Thank you for contacting the City of Sammamish regarding the current Shoreline Substantial Development Permit Application for East Lake Sammamish Trail Segment 2B (SSDP2016-00415).

I am submitting my comments to the King County ELST section B, 60% plan.

Subject: King County SSDP Permit--South Sammamish Segment B Homeowners comments regarding 60% Design Plan

60% Sammamish Trail design drawings Station Point 458-00

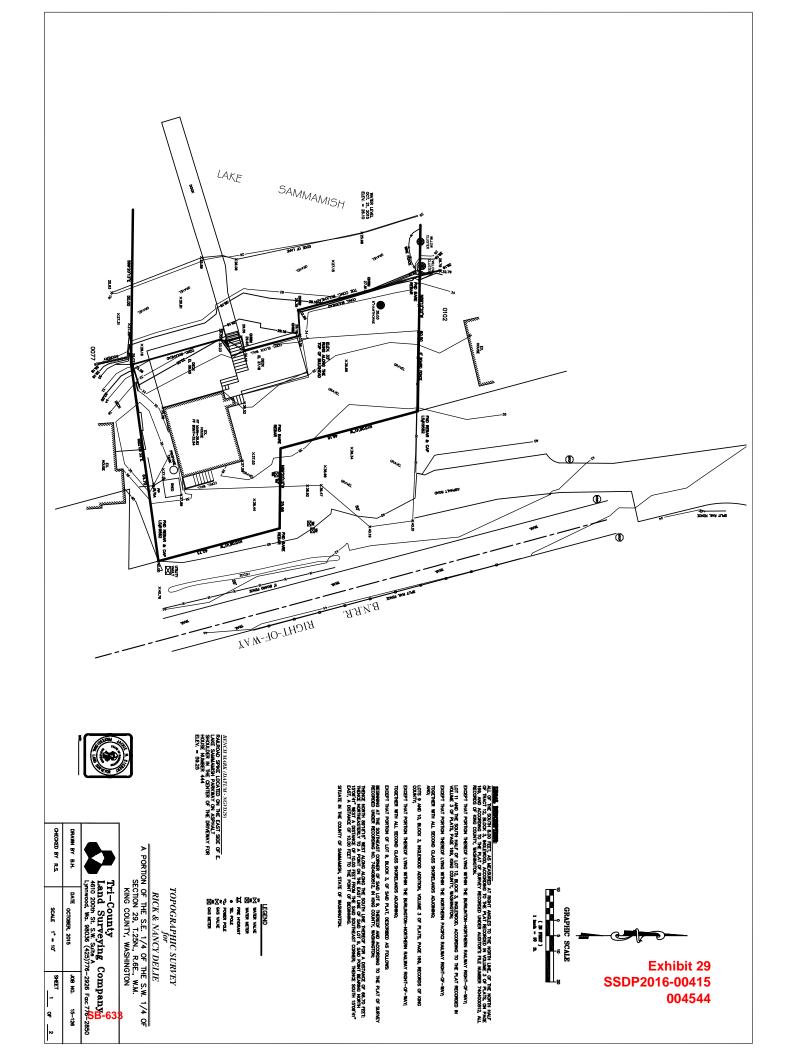
As owner of this property, we noticed a major discrepancy in the design drawings when reviewing the plans on 1/17/17. Our property on the plans does not reflect the actual lot shape, where a portion extends toward the trail approximately 25 feet from what is shown. We have attached a copy of the survey prepared for this property in October 2015. We are concerned that if our property is not depicted correctly on the 60% Trail design drawings, there may be issues in the future. We encourage you to revise the design plans to properly reflect the lot shape.

COMMENT #1: SHED LOCATION

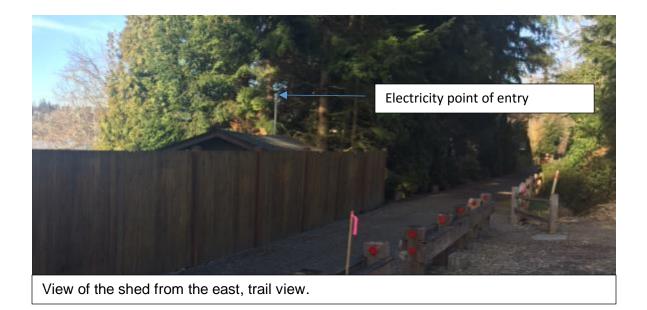
The current 60% design drawing show a clearing and grubbing (CG) line extending approximately 25 feet from the back of the current guardrail west towards the lake. We currently have a shed located within the CG line. This shed has been in this location for decades and is the single point of entry for the electricity and cable to our property and to the property that is adjacent to the north. Removal of the shed will be extremely problematic as the property is steeply graded and the shed is actively being used as storage.

- If they County demands the shed be removed, is the County covering the removal cost?
- How will the County ensure our property will still have access to electricity and cable?
- If the shed is removed, will the County return the shed to its original location?
